Date: August 14, 2024
Subject: Requesting Class II permissive change for FCC ID: 2AVMJX6

The purpose of this letter is to request a Class II Permissive change for FCC ID: 2AVMJX6, original granted on 10/18/2022.

Applicant: XPLORA Technologies AS

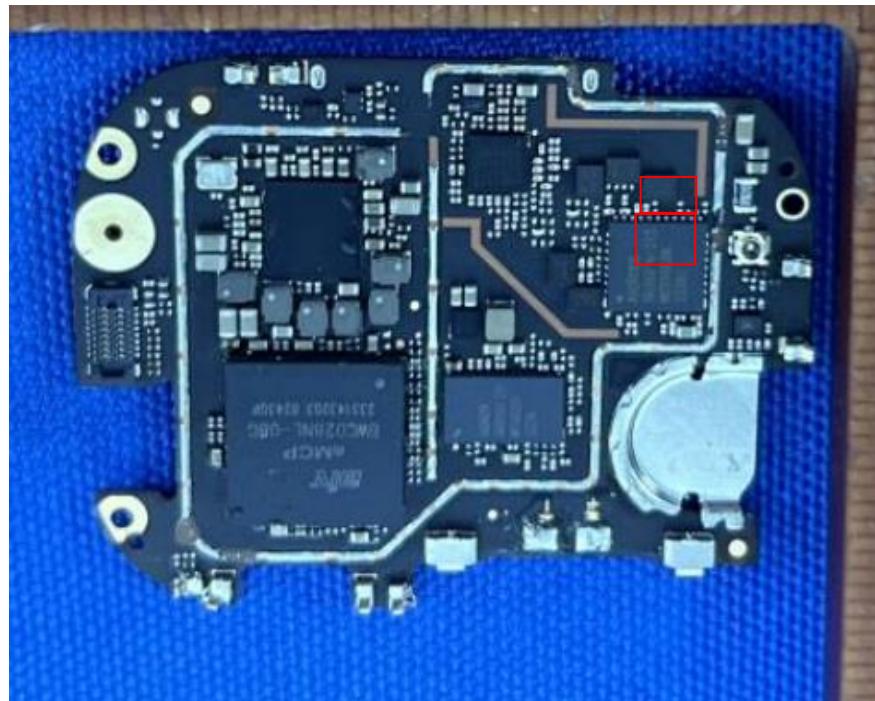
A. DESCRIPTION OF PRODUCT CHANGES

1. Changed manufacturer for the capacitor (C4071, C4062);
2. Changed manufacturer for the capacitor (R4002, R4003);
3. Removed the inductor(L4005);
4. More details as bellows;

Placement	Model	Parameter	Supplier	Remark
C4071	0 Ω	RC0201JR-070RL	Yageo	
		0201WMJ0000TEE	uniohm	new supplier
R4002	15NH	SDCL0603Q15NJT02B01	Sunlord	
		SDCL0603Q15NJT02B03	Sunlord	new supplier
C4062	22PF	V220J0201C0G500NAT	微容	
		C0201C0G220J500NTA	宇阳	new supplier
R4003	0 Ω	RC0201JR-070RL	Yageo	
		0201WMJ0000TEE	uniohm	new supplier
L4005	removed

Original

New
